Product Advisory (PA)

Subject: Correction of Manufacturing Part Number (MPN) Product Label to remove Pb-free designation symbol

Publication Date: 11/14/2023

Appendix B : Remove Pb-Free designation symbol

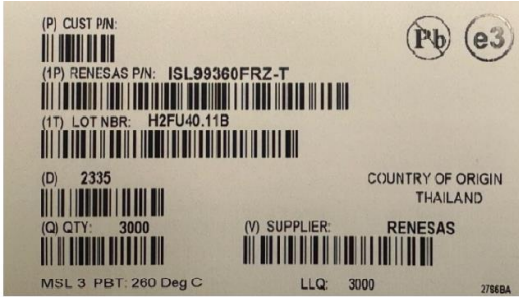
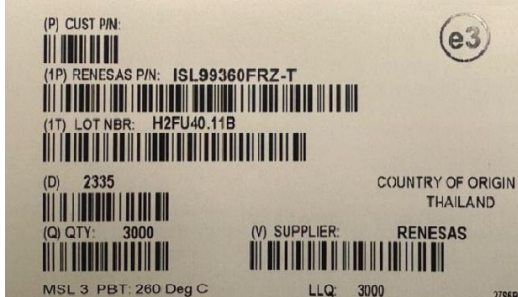
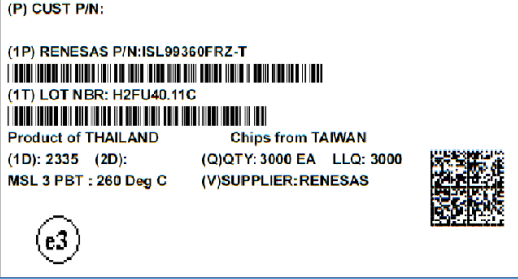
Details	Existing Label (From)	New Label (To)
<p>Shipping Label (Interior Label – 1D label)</p>	 <p>(P) CUST P/N: (1P) RENESAS P/N: ISL99360FRZ-T (1T) LOT NBR: H2FU40.11B (D) 2335 COUNTRY OF ORIGIN THAILAND (Q) QTY: 3000 (V) SUPPLIER: RENESAS MSL 3 PBT: 260 Deg C LLQ: 3000 2786BA</p>	 <p>(P) CUST P/N: (1P) RENESAS P/N: ISL99360FRZ-T (1T) LOT NBR: H2FU40.11B (D) 2335 COUNTRY OF ORIGIN THAILAND (Q) QTY: 3000 (V) SUPPLIER: RENESAS MSL 3 PBT: 260 Deg C LLQ: 3000 2786BA</p> <p>Pb-Free logo is removed.</p>
<p>Shipping Label (Interior Label – 2D label)</p>	 <p>(P) CUST P/N: (1P) RENESAS P/N: ISL99360FRZ-T (1T) LOT NBR: H2FU40.11C Product of THAILAND Chips from TAIWAN (1D): 2335 (2D): (Q) QTY: 3000 EA LLQ: 3000 MSL 3 PBT : 260 Deg C (V) SUPPLIER: RENESAS</p>	 <p>(P) CUST P/N: (1P) RENESAS P/N: ISL99360FRZ-T (1T) LOT NBR: H2FU40.11C Product of THAILAND Chips from TAIWAN (1D): 2335 (2D): (Q) QTY: 3000 EA LLQ: 3000 MSL 3 PBT : 260 Deg C (V) SUPPLIER: RENESAS</p> <p>Pb-Free logo is removed.</p>
